PROPOSED TECHNICAL SPECIFICATION CHANGES

MANAGEMENT ORGANIZATION

TITLES

POWER AUTHORITY OF THE STATE OF NEW YORK  
JAMES A. FITZPATRICK NUCLEAR POWER PLANT  
DOCKET NO. 50-333  
DPR-59

Figure 5.2-2  
Management Organization-Offsite  
Radiological Environmental  
James A. FitzPatrick Nuclear  
Power Plant

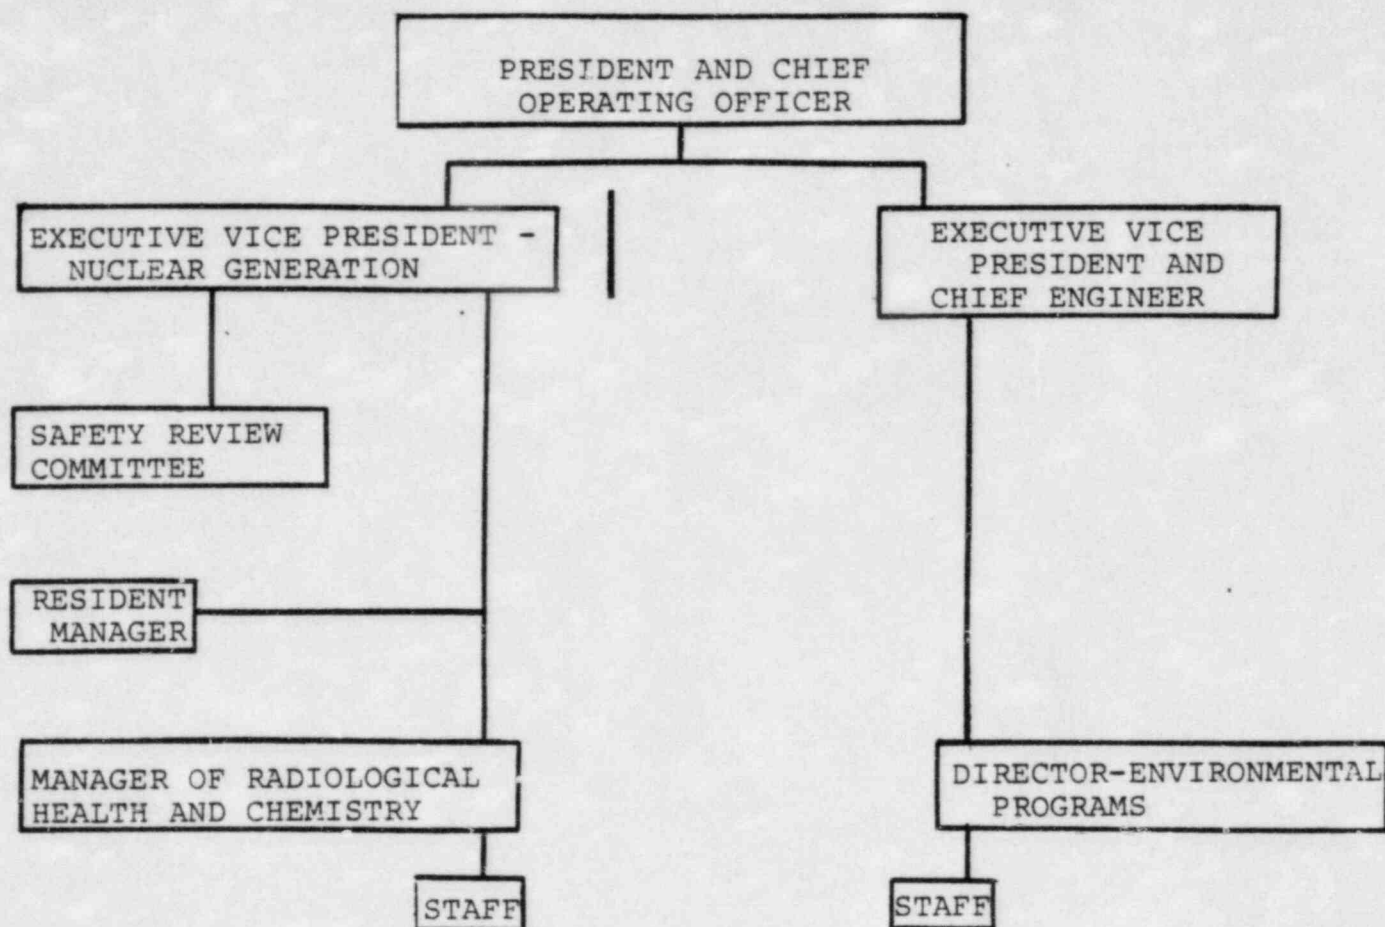
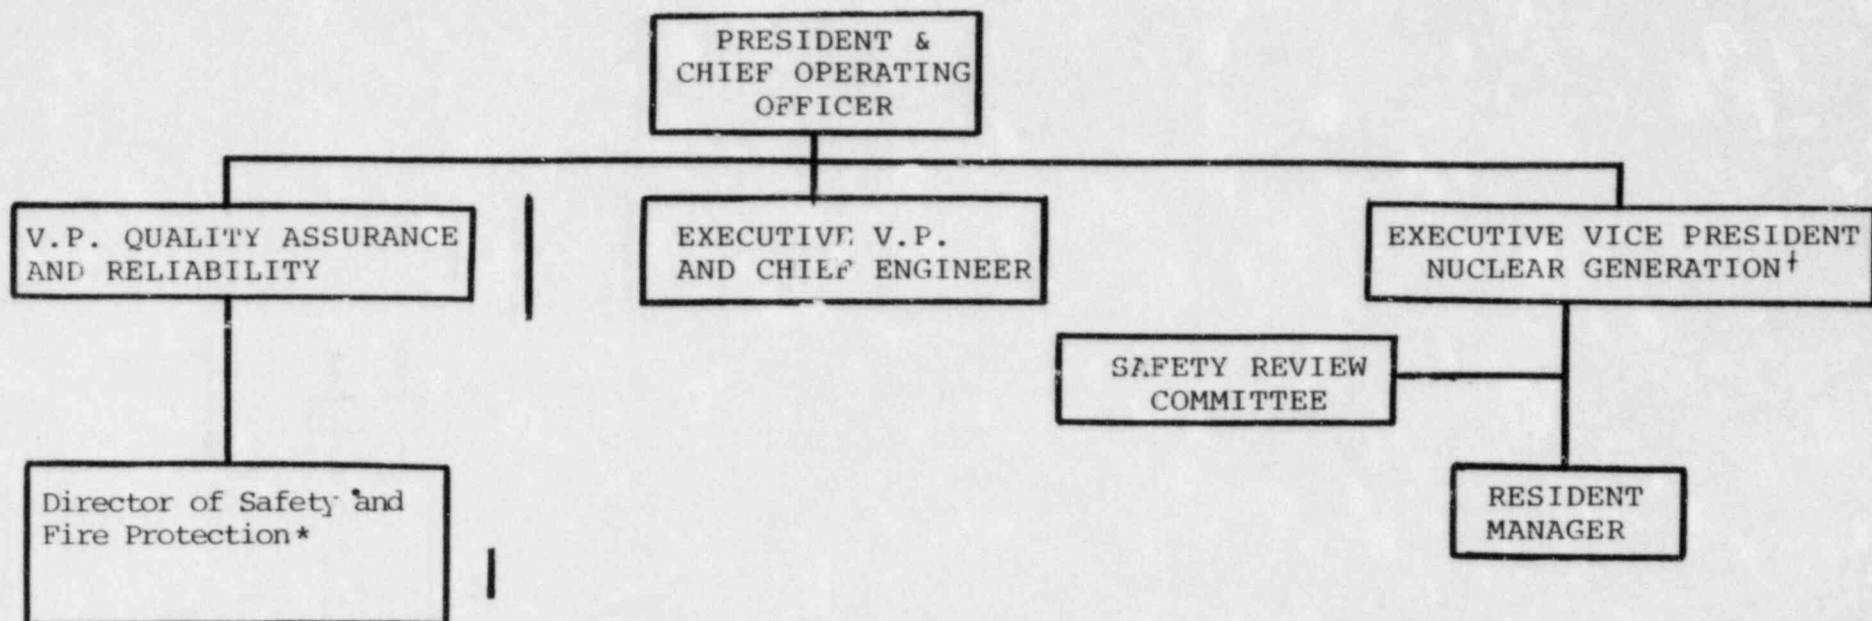
The title of Senior Vice President - Nuclear Generation is changed to Executive Vice President - Nuclear Generation in Appendix B, Figure 5.2-2 (page 44) and in Appendix A, Sections 6.1 (page 247), 6.5.1 F and G (page 250), 6.5.2.8g (page 252a), 6.5.2.9 (page 252a), 6.5.2.10 a through c (page 252a), 6.5.2.11 (page 253), 6.6 B (page 253), and 6.7 B and C (page 253).

FIGURE 6.1-1

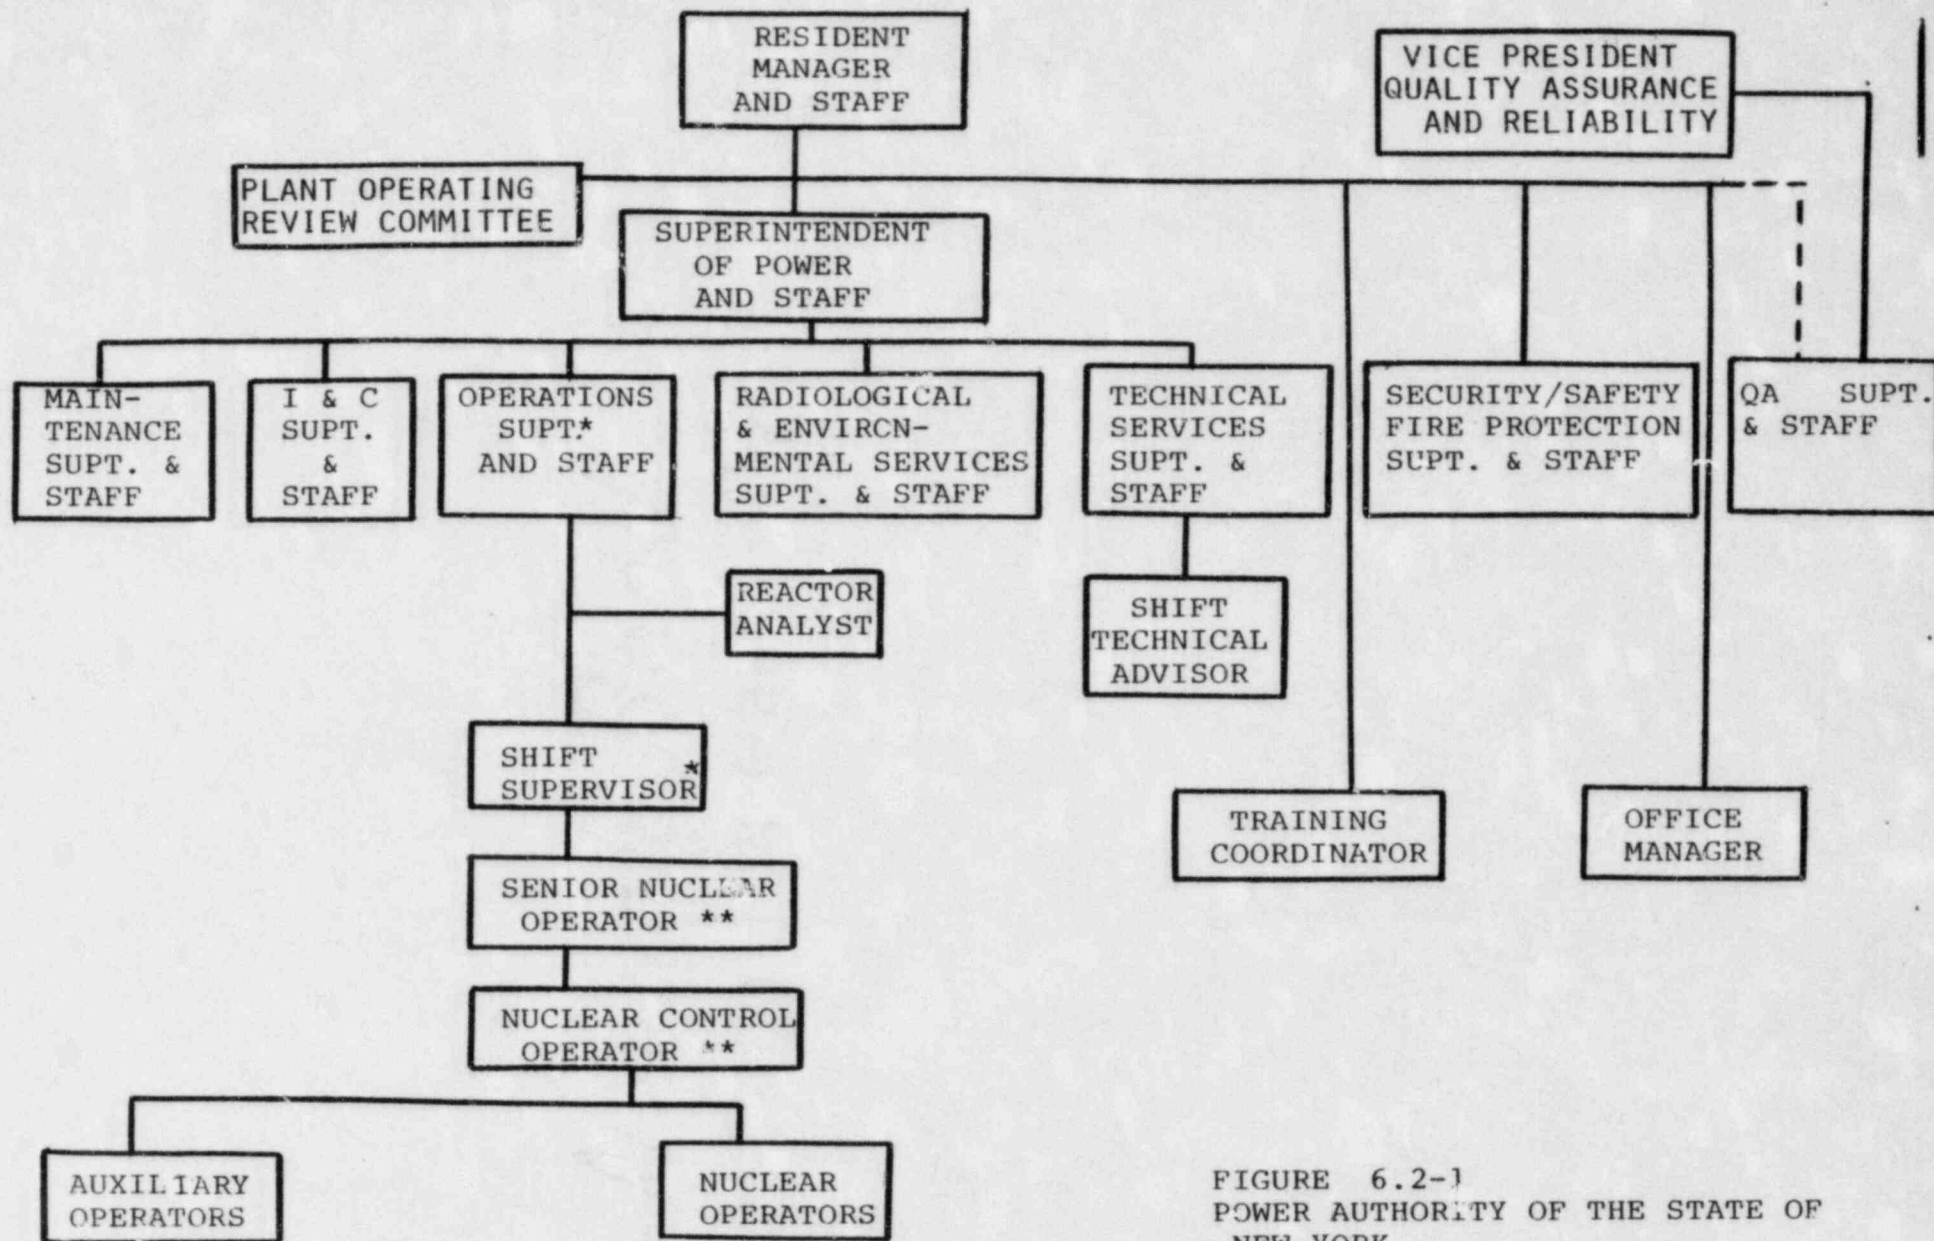
In Figure 6.1-1 of Appendix A, page 259, "Procedures and Performance" is replaced by "Quality Assurance and Reliability". Also in this figure, the position entitled "Director of Safety and Fire Protection Procedures and Performance" is renamed as "Director of Safety and Fire Protection." The phrase "which is part of the Quality Assurance and Reliability Department," is added to the sentence denoted by an asterisk. Also in this sentence, "Safety and Fire Protection" has been changed to "the Safety and Fire Protection Division".
